**Sent:** 11/02/2022 1:38:01 PM  
**Subject:** DA 2021/2622 65 HILLSIDE ROAD NEWPORT  
**Attachments:** 65 HILLLSIDE ROAD NEWPORT SUBMISSION TO COUNCIL.pdf;

**DA2021/2622**

**ADDRESS – 65 HILLSIDE ROAD NEWPORT**

**PERSPECTIVE OF PROPOSAL FROM SUBMITTED PLANS**

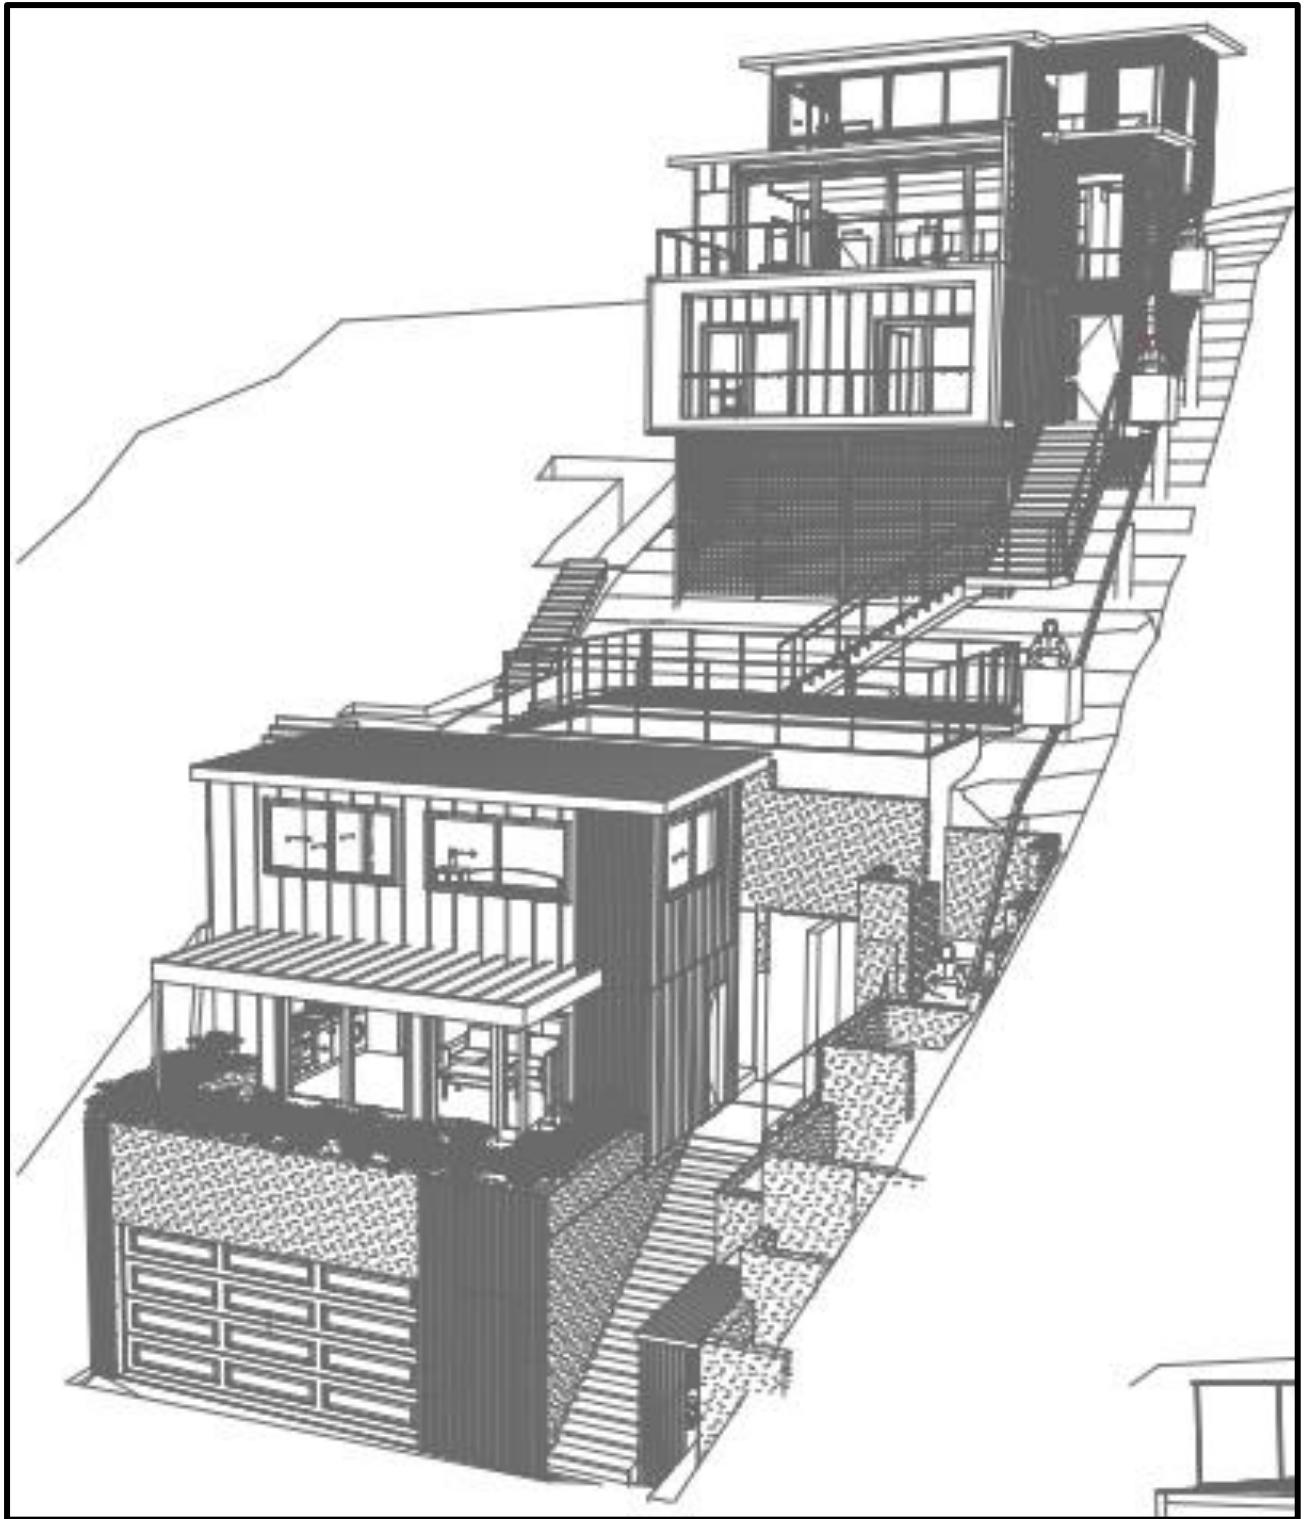
The provisions of this control are clear in that they seek to enhance the existing streetscapes and promote a scale and density that is in scale with the height of the natural environment. The proposal which seeks consent for a three storey development containing a secondary dwelling at a distance of 3.37 m from the front boundary will not enhance the existing streetscapes nor result in a structure that is in scale with the height of the natural environment. This three-storey element when coupled with the requested breach of the height control for the principal dwelling cannot achieve the outcomes sought by this control.

**STREET VIEW PHOTOGRAPH SHOWING SITE VEGETATION, NOW LARGELY REMOVED.**

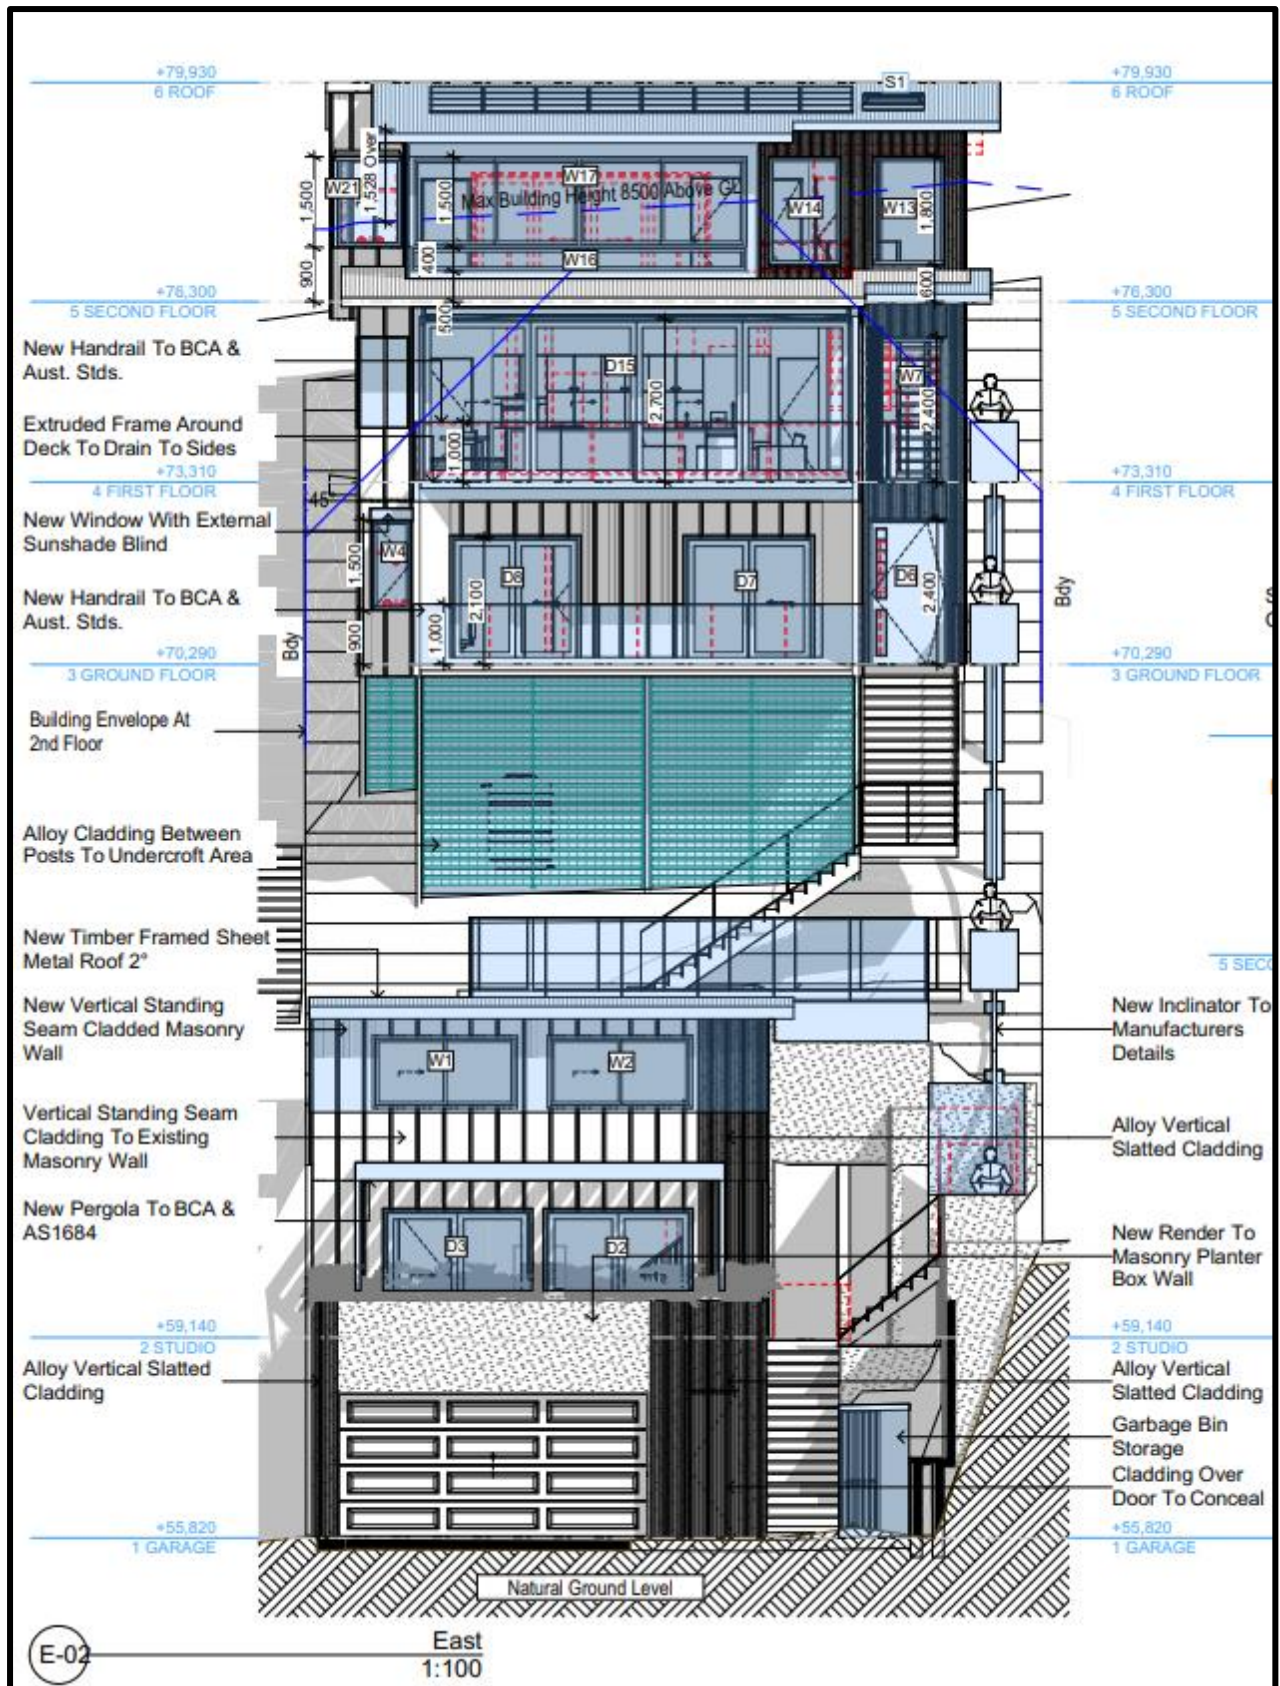
The following photograph (from Street View) indicates the historical presence of generous amounts of vegetation on the subject site, particularly on the sensitive interface between the subject site and my client's site at 67 Hillside Road.

The large tree shown in the above photograph has now been removed whilst the vegetation between the two properties shown in the above photograph has also been removed and is proposed to be replaced with an inclinator, thereby removing any opportunity for meaningful landscaping to be provided between areas of private open space on the two properties.

EAST ELEVATION EXTRACT FROM SUBMITTED PLANS

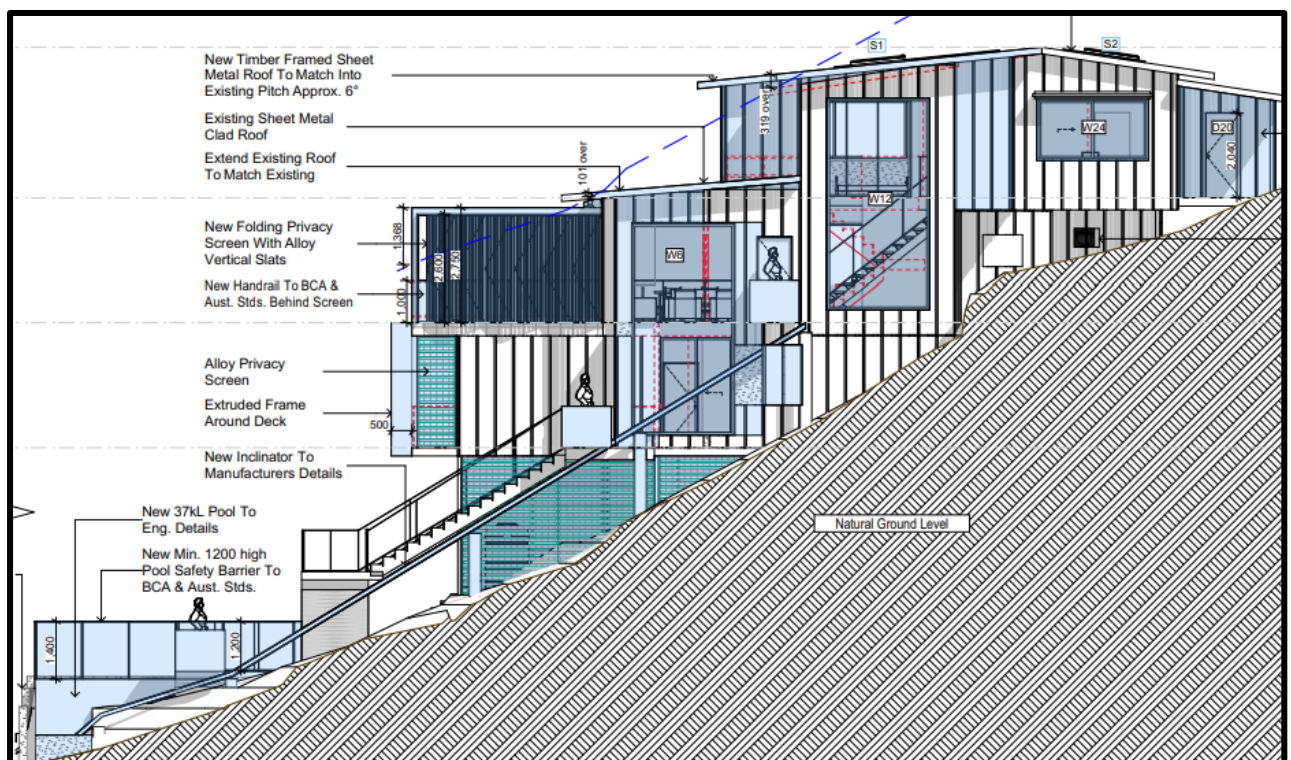
The extract from the architectural plans on the following page of this submission clearly illustrates the absence of a sensitive design which clearly imposes significant privacy impacts as illustrated by the persons within the inclinator carriage.

The proposed elevation also clearly demonstrates the dominance of the built form comprising a three-storey granny flat/secondary dwelling within the required front boundary setback, excessive height of the main dwelling as indicated in the submitted Clause 4.6 objection and the subsequent loss of any opportunity for meaningful landscaping to be provided on site.

**ELEVATION OF PROPOSED INCLINATOR VIEWED FROM 67 HILLSIDE ROAD**

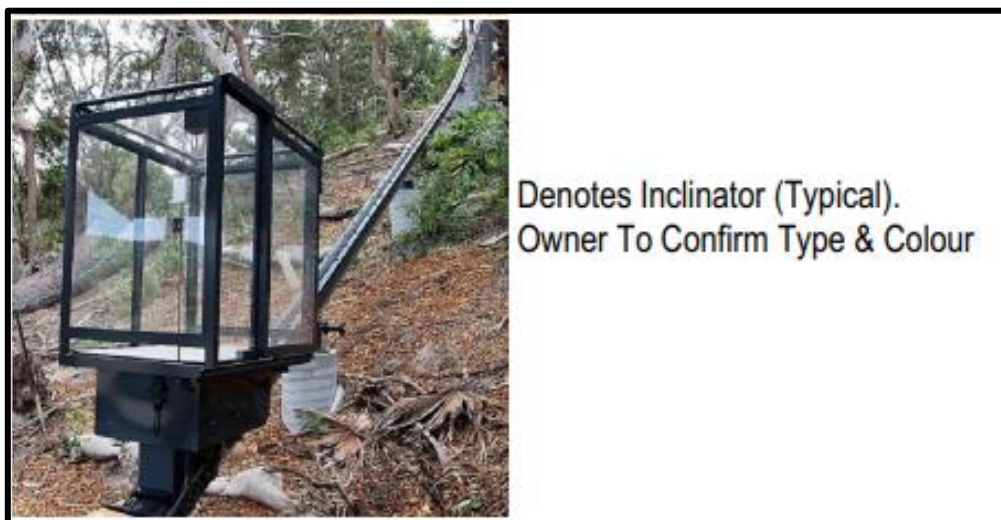
The proposal incorporates a proposed incline passenger lift (inclinator) directly adjacent to a timber balcony and in full view of several windows on my client's site at 67 Hillside Road.

The proposal which will result in a severe intrusion on the amenity of my client's amenity fails the majority of the requisite controls as it is located directly adjacent to the living area of 67, has no opportunity for landscaping, will result in significant acoustic disturbance and will have a visual and acoustic impact that will be significantly exacerbated by its elevation of over 2.5 m in some places.

The location and height of the proposed incline are offensive as the impacts upon privacy both visual and acoustic will be considerable as there is no opportunity for any ameliorating physical barriers such as privacy screens or landscaping due to the presence of the inclinator and its carriage being on or in very close proximity to the boundary and elevated well above ground level.
